Figure 19 WIRING SIDE BOARD (P.W.B. NO. F0485AF-3)

Figure 18 SCHEMATIC DIAGRAM (P.W.B. NO. F0485AF-3)

Figure 20 SCHEMATIC DIAGRAM (P.W.B. NO. F0485AF-4)

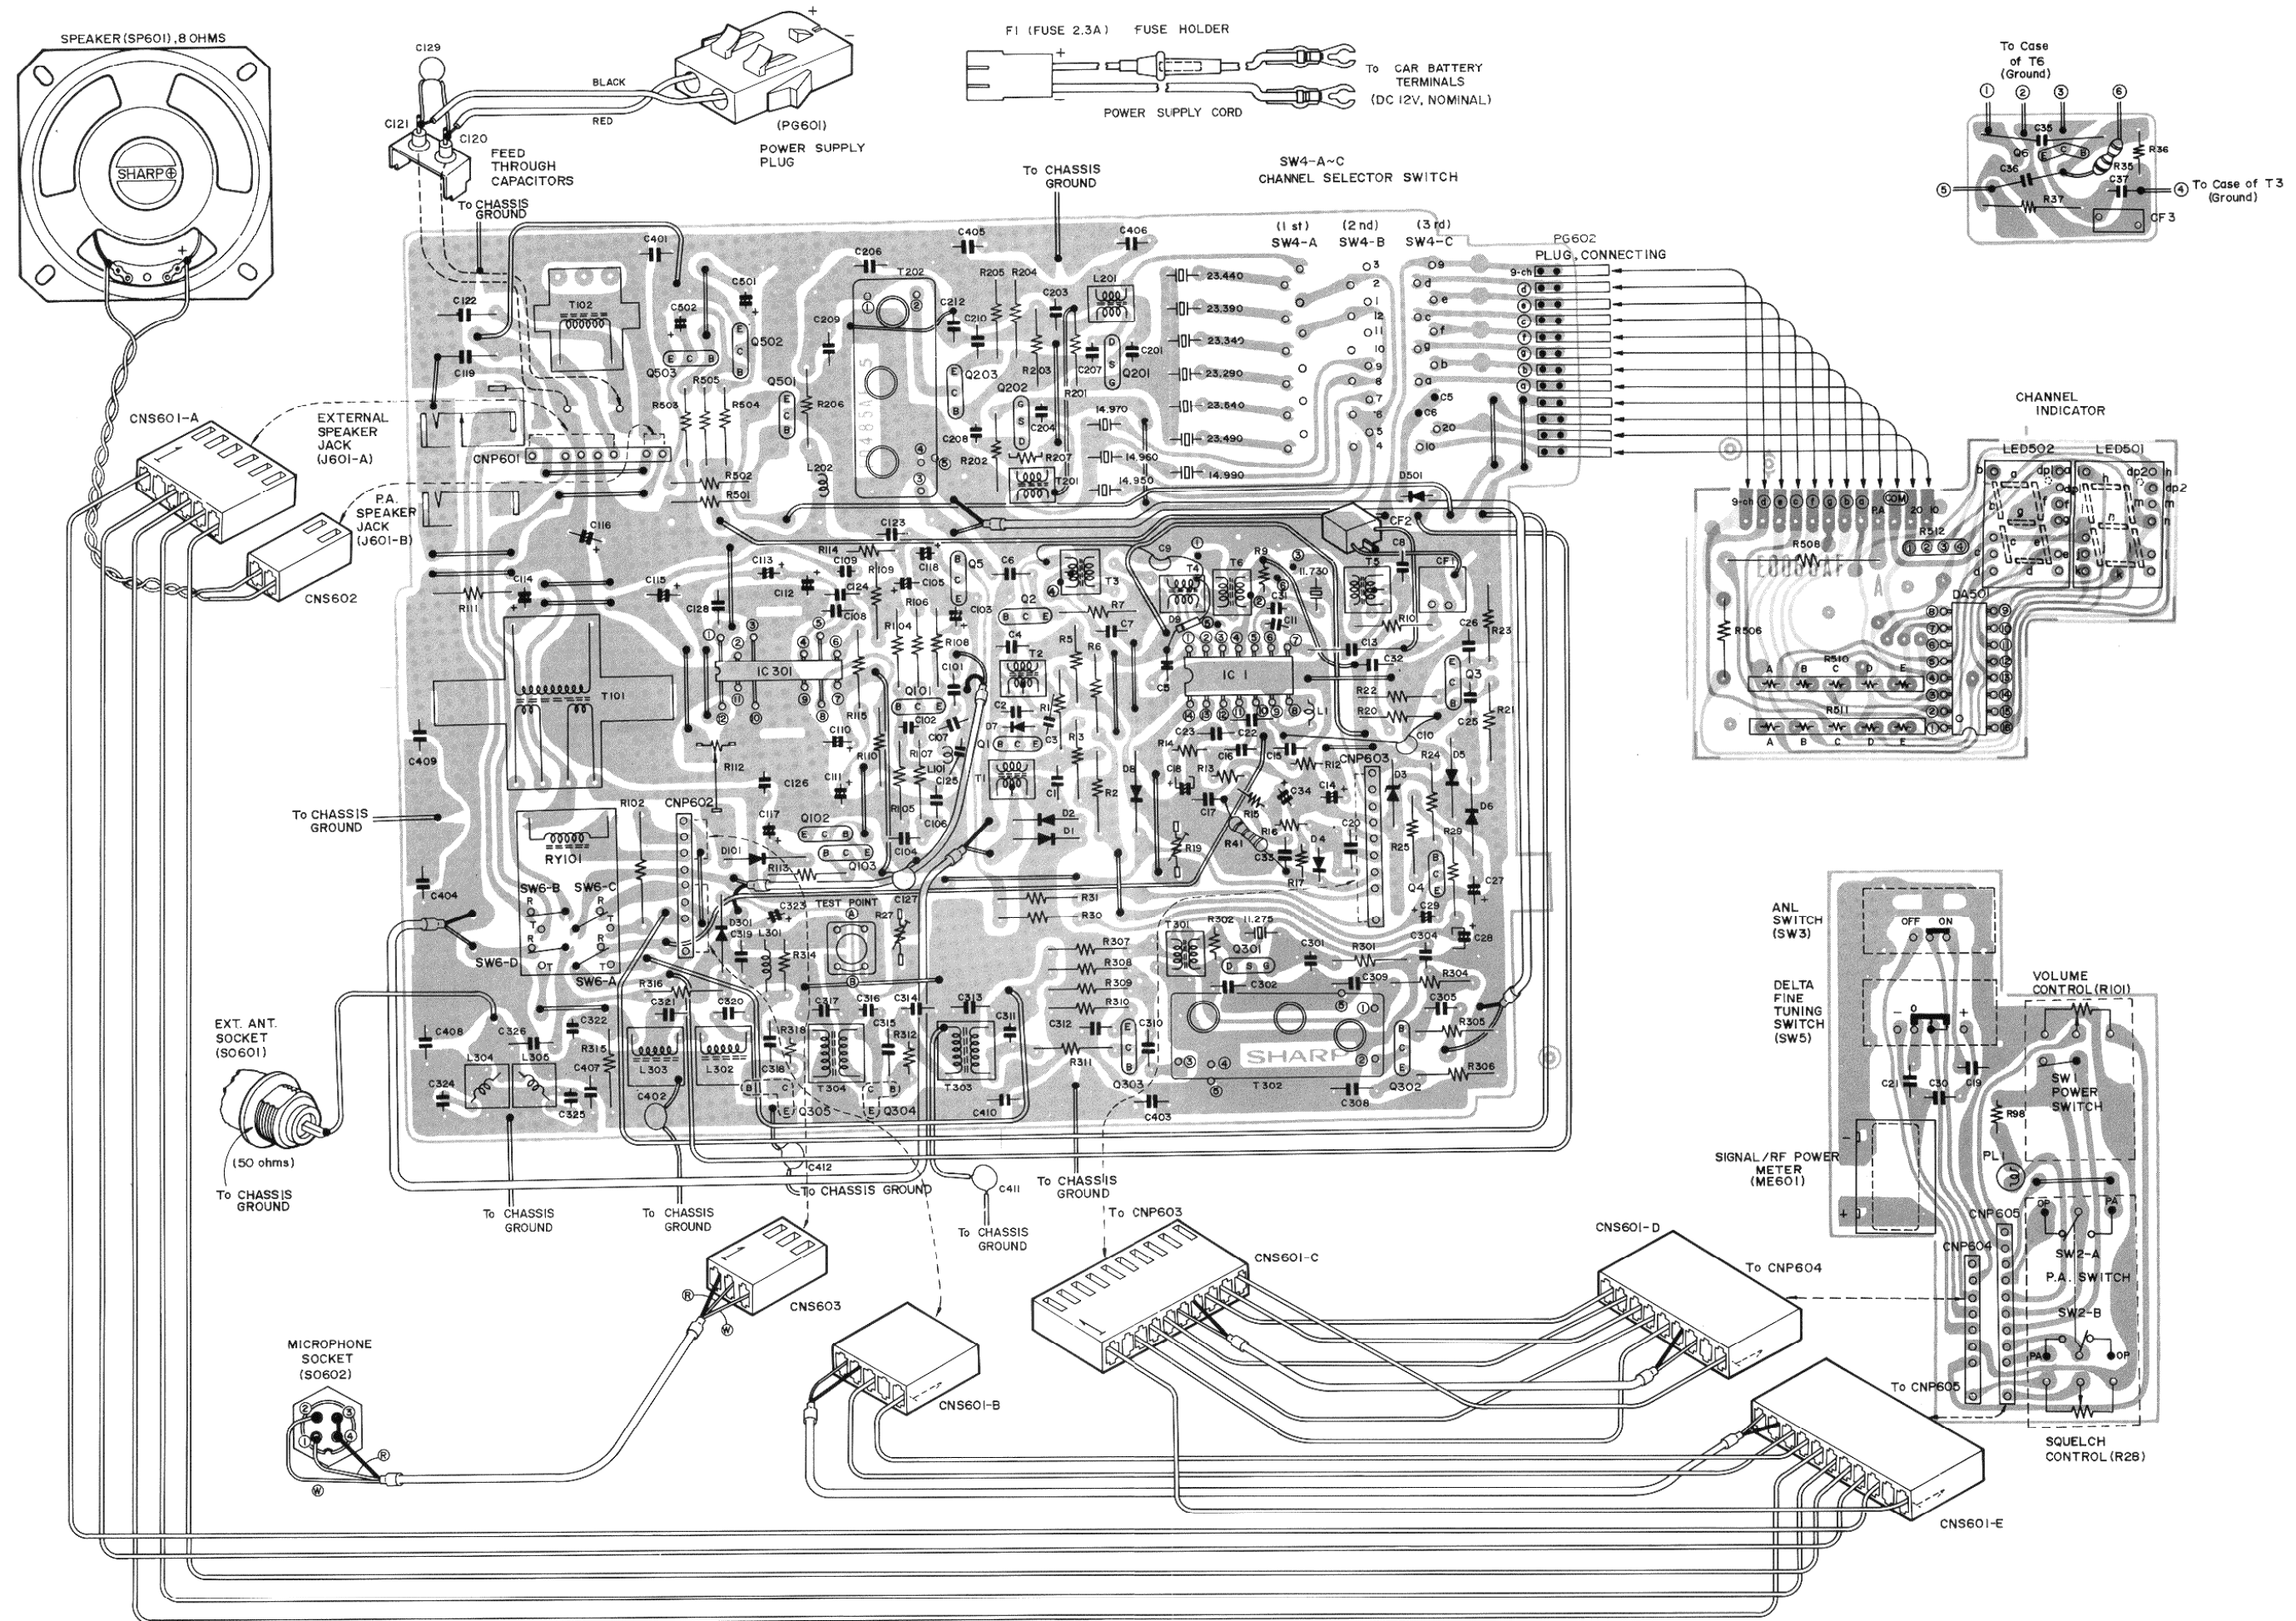
- NOTE:
- 1) In case of adding ceramic filter CF-2 and CF-3.
(Reference figures are 20 and 21.)
 - ① Add a ceramic filter CF-2 (RFILA0050AFZZ)
 - ② Add a ceramic filter CF-3 (RFILA0001AFZZ)
 - ③ Change the capacitor C37 from 0.01MFD to 680PF (VCCSPU1HL681J)
 - ④ Cut the printed circuit pattern, the place is shown on Figure 21-①.
 - 2) In case of adding ceramic filter CF-3.
(Reference figures are 20 and 21)
 - ① Add a ceramic filter CF-3 (RFILA0001AFZZ)
 - ② Change the capacitor C37 from 0.01MFD to 680PF (VCCSPU1HL681J)
